This errata sheet provides information about known device issues affecting Arria® V production devices.

Device Errata for Arria V Production Devices

Figure 2. Arria V GX/GT LVDS DPA RX Supported and Unsupported Data Rates

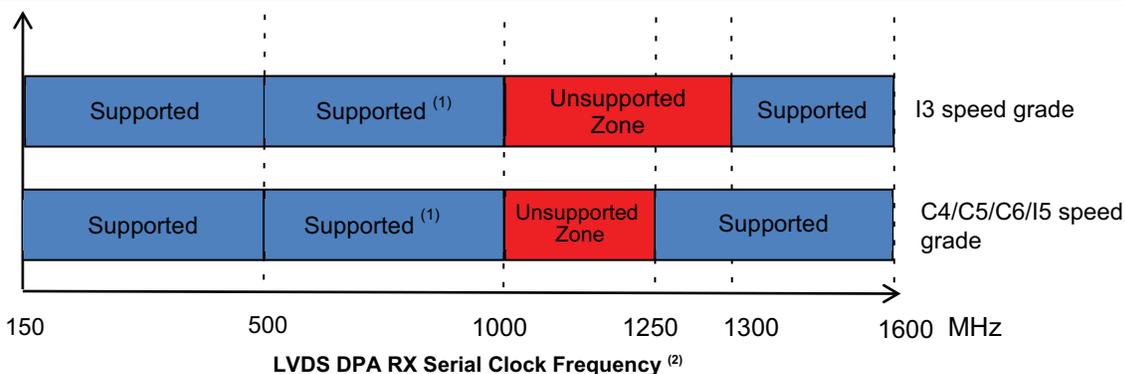
DPA mode or soft-CDR mode is not supported for specific LVDS data rate as shown in [Figure 2](#). If the RX channels with DPA are operating in the unsupported zone, bit errors may occur. This limited LVDS data rate support impacts early die revision Arria V GX/GT device when LVDS receiver channels operating in DPA mode or soft-CDR mode. LVDS receiver channels operating in non-DPA are not affected. The unsupported data rate zones are dependent on device speed grade as shown in [Figure 2](#). The affected Arria V GX/GT die revisions are shown in [Table 7](#).

- (1) Supported with recompilation in Quartus II version 13.0 and later. Not supported in Quartus II version 12.1SP1 and earlier. If the RX channels with DPA are operating in this zone with Quartus II version 12.1SP1 and earlier, bit errors may occur.
- (2) The scale of the LVDS DPA RX serial clock frequency is for illustration purposes only.

For the LVDS data rate solutions in the unsupported zones, refer to [Table 5](#) and [Table 6](#).
